The Commission has issued the enclosed Amendment No. ³³ to Facility Operating License No. DPR-51 for Arkansas Nuclear One, Unit No. 1 (ANO-1). The amendment consists of changes to the Technical Specifications in response to your license amendment request dated March 14, 1978.

The amendment modifies the Technical Specifications for ANO-1 to increase the volume requirements and to modify the concentration requirements of the boric acid addition tank.

Amendment No. 33
License No. DPR-51

SAFETY EVALUATION BY THE OFFICE OF NUCLEAR REACTOR REGULATION
SUPPORTING AMENDMENT NO. 33 TO FACILITY OPERATING LICENSE NO. DPR-51

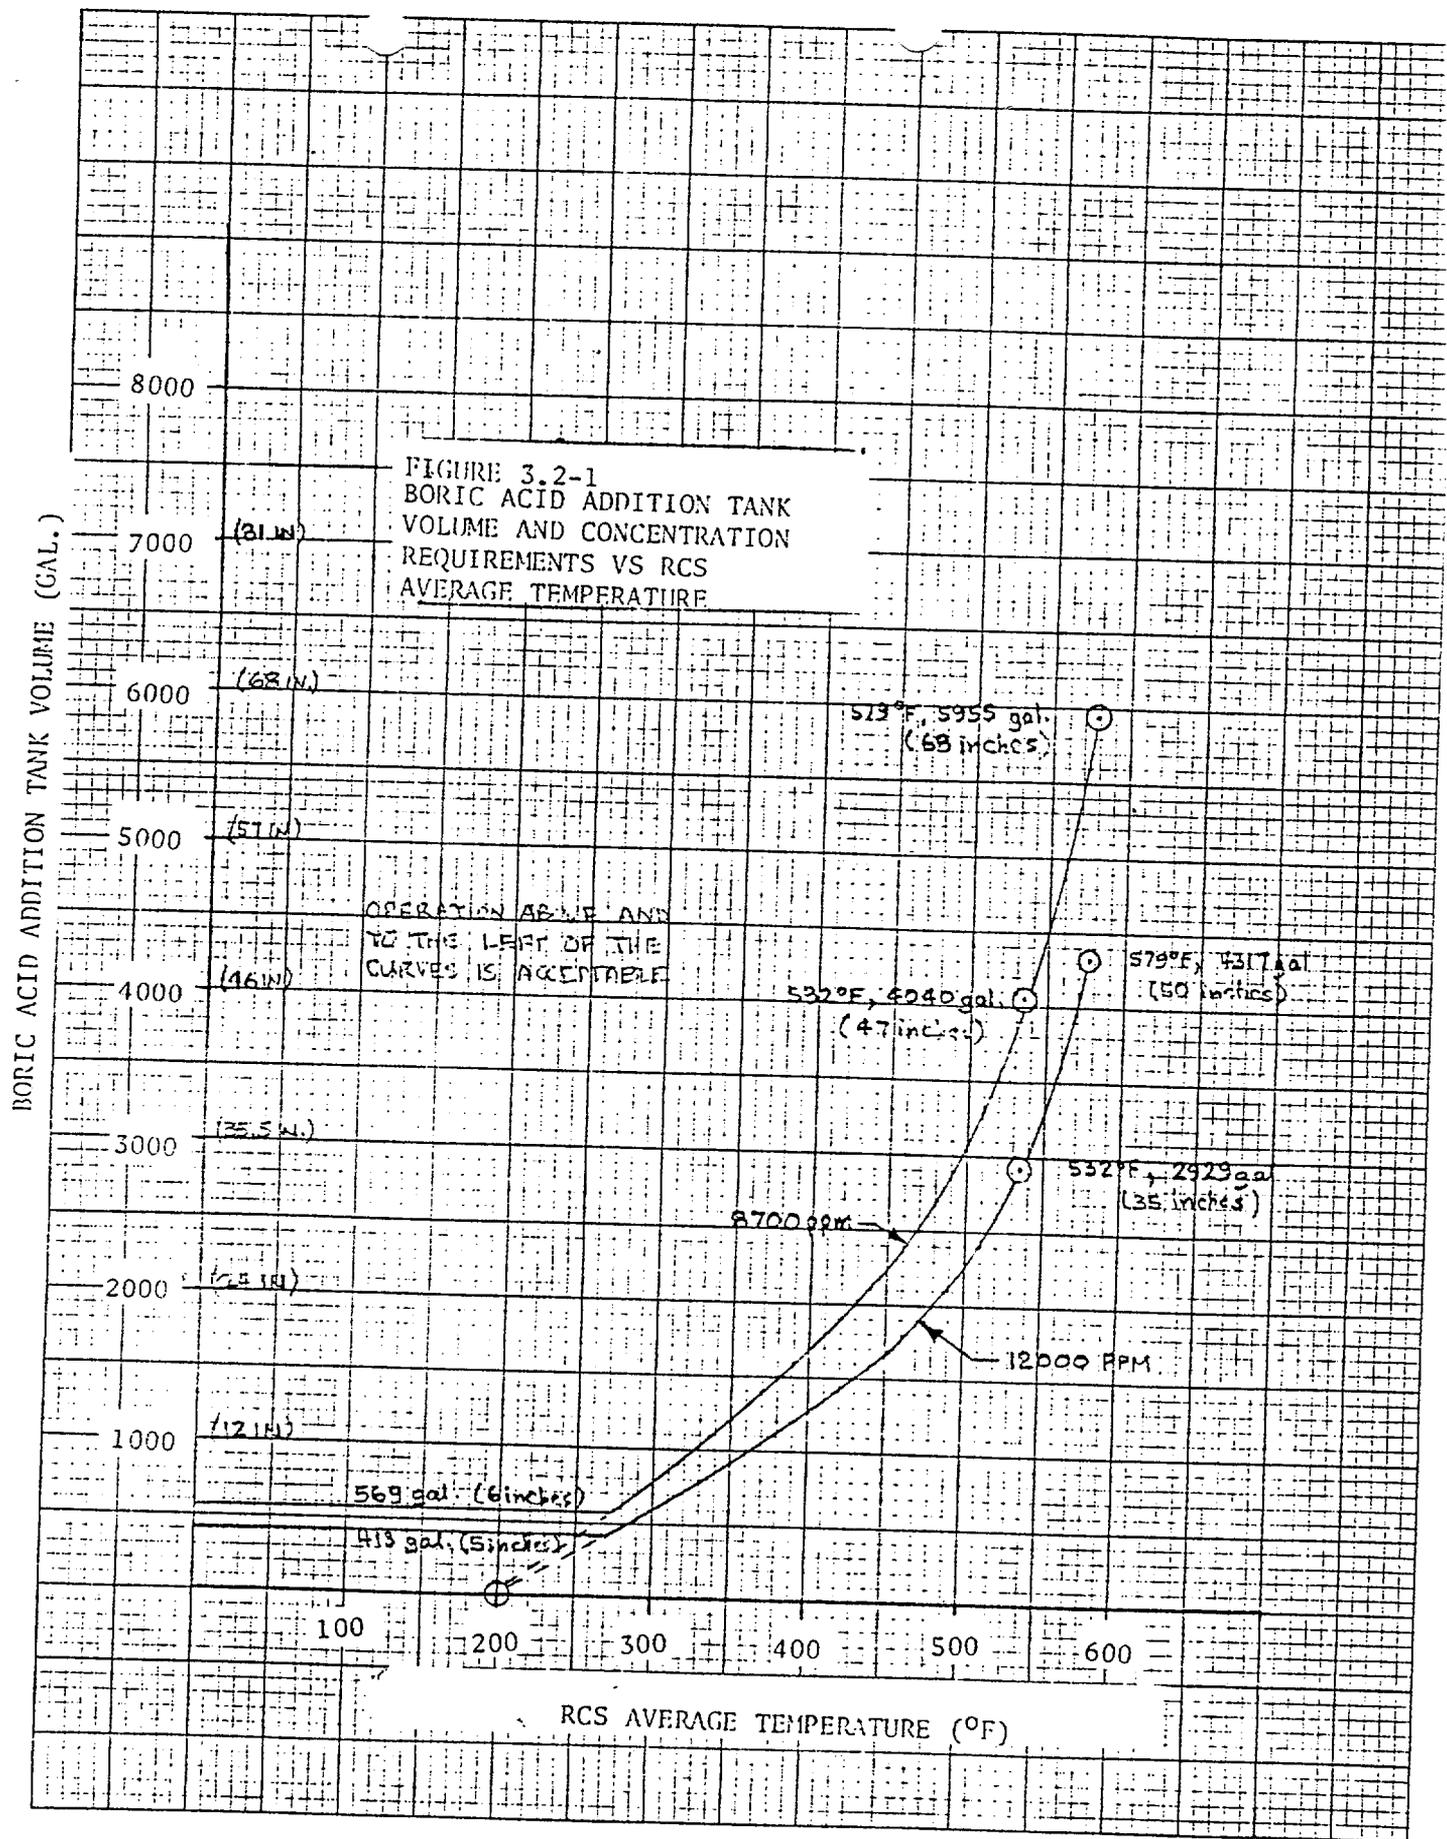
Minimum volumes (including a 10% safety factor) as specified by Figure 3.2.1 for the boric acid addition tank or 27,633 gallons of 2270 ppm boron as boric acid solution in the borated water storage tank (3) will each satisfy this requirement. The specification assures that adequate supplies are available whenever the reactor is heated above 200°F so that a single failure will not prevent boration to a cold condition. The minimum volumes of boric acid solution given include the boron necessary to account for xenon decay.

The principal method of adding boron to the primary system is to pump the concentrated boric acid solution (8700 ppm boron, minimum) into the makeup tank using the 25 gpm boric acid pumps. Using only one of the two boric acid pumps, the required volume of boric acid can be injected in less than three hours. The alternate method of addition is to inject boric acid from the borated water storage tank using the makeup pumps; the required volume of boric acid can be injected in less than two hours using only one of the makeup pumps.

Concentration of boron in the boric acid addition tank may be higher than the concentration which would crystallize at ambient conditions. For this reason and to assure a flow of boric acid is available when needed this tank and its associated piping will be kept 10°F above the crystallization temperature for the concentration present. Once in the makeup system, the concentrate is sufficiently well mixed and diluted so that normal system temperatures assure boric acid solubility.

The proposed change would change the boric acid addition tank volume and concentration requirement to be dependent upon average reactor coolant temperature. The proposed change would 1) increase the required volume of boric acid solution at 8700 ppm when the reactor would be in the hot shutdown condition, and 2) provide sufficient quantity of boric acid to assure a 1% delta k/k shutdown margin at the worst time of core life with a stuck control rod assembly and after xenon decay at all temperatures above cold shutdown. The proposed modification would also provide an alternate or smaller volume versus average reactor coolant temperature requirement of the boric acid addition tank with boric acid solution concentration of 12,000 ppm. This specification would also assure a 1% shutdown margin above 200°F. For both proposed requirements the boric acid solution would be required to be maintained at a temperature at least 10°F above the crystallization temperature. The proposed change in format for the boric acid volume requirements of the boric acid addition tank would reduce the volume requirements over the present requirements when the reactor coolant would be at temperatures less than the temperature of the hot shutdown condition. This would allow less delay during plant cooldown to make up the boric

acid batches to the boric acid addition tank. It would maintain at least a 1% shutdown margin above 200°F, which is acceptable.
